FLIGHT DESIGN USA SAFETY DIRECTIVE No.8

Engine Mount Bolts

- Pages: Two (2)
- Supersedes: Technical Advice No.8, Dated June 1st, 2005
- Re-issue to conform to ASTM format
- Date Issued: January 1, 2006
- Date Effective: January 1, 2006
- Scope: CT, CT2K, and CTSW in all versions up to and including serial No. 05-05-01

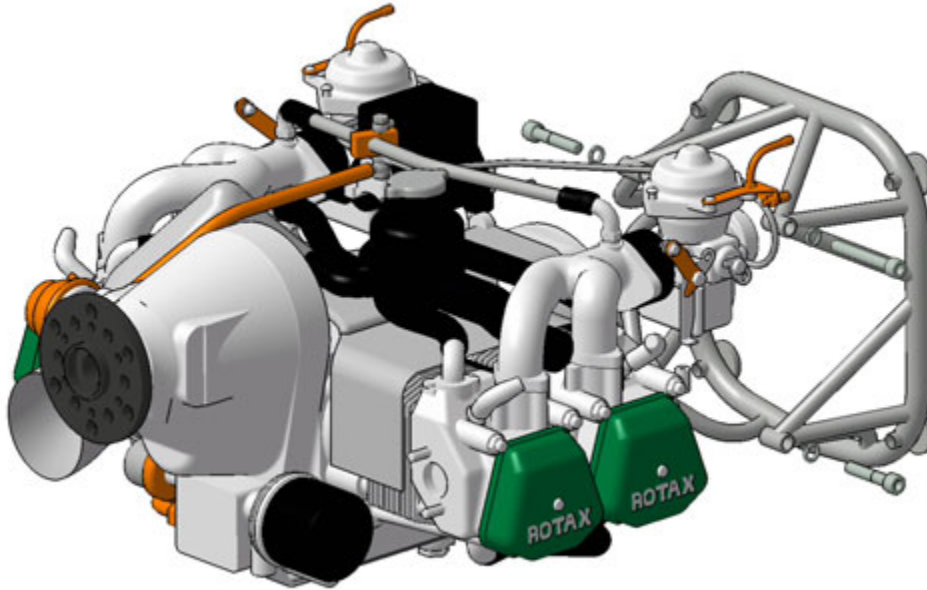
Three aircraft were found to have partially loosened engine mount bolts that connect the Small Engine Frame to the engine.

Change the torque moment of the bolts (part No. C9996511 & C9996098F), which connect the Small Engine Frame to the engine. The original torque moment was 30 Nm. (22ft.lbs). The new Rotax recommended values are a minimum of 35 Nm. (25.8ft.lbs), not to exceed 40 Nm. (29.5ft.lbs).
